Subject: **Response to Portion of NRC Request for Additional Information Letter No. 124 Related to ESBWR Design Certification Application - Nuclear Boiler System - RAI Number 5.2-67**

Response to Portion of NRC Request for Additional Information Letter No. 124 Related to ESBWR Design Certification Application

Nuclear Boiler System

RAI Number 5.2-67

Figure 5.2-4a. MSIV Closure With Flux Scram

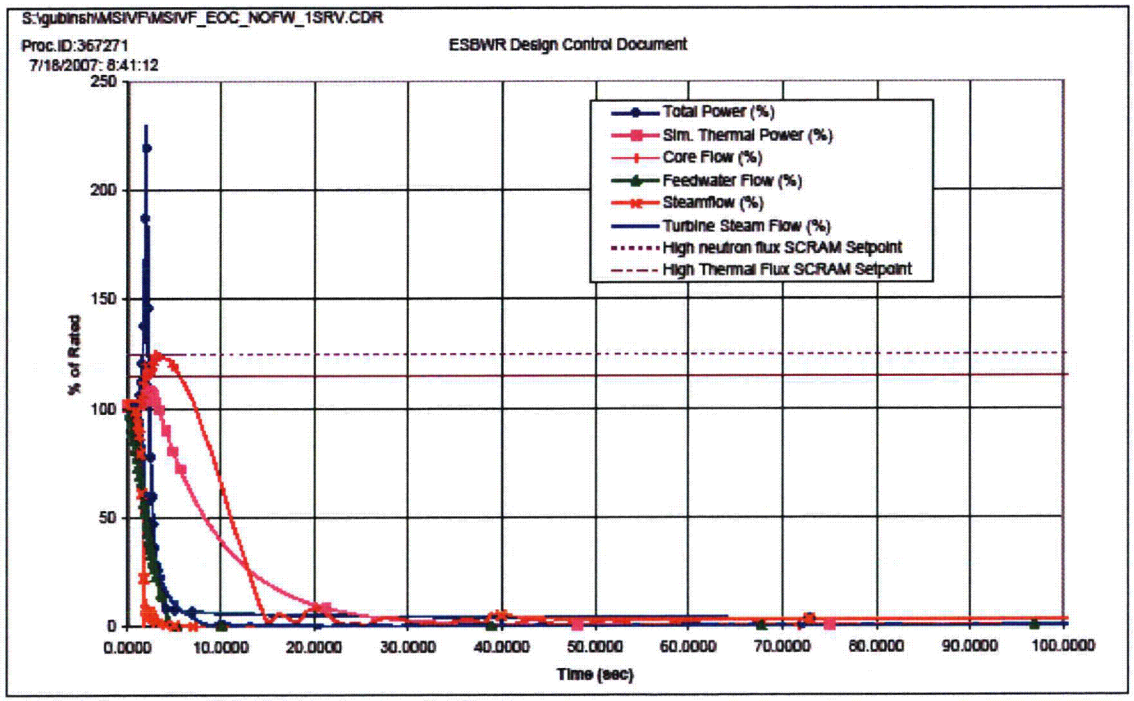
Figures 5.2-4a through 4f were deleted in Rev.4 with a statement that "Obsolete Figure to be replaced later." Add the Figures. Confirm that credit is taken only for one SRV for the analysis results shown in the Figures.

Updated graphs are to be incorporated into DCD Tier 2, Figures 5.2-4a through 5.2-4f. GEH confirms that the updated graphs are for a case modeled as a single safety relief valve (SRV) response to the main steam isolation valve (MSIV) full closure event, which is the bounding event for overpressure at Service Level B evaluated in DCD Tier 2, Subsection 5.2.2.

DCD Tier 2, Figures 5.2-4a through 5.2-4f, will be updated as shown in the attached markup.
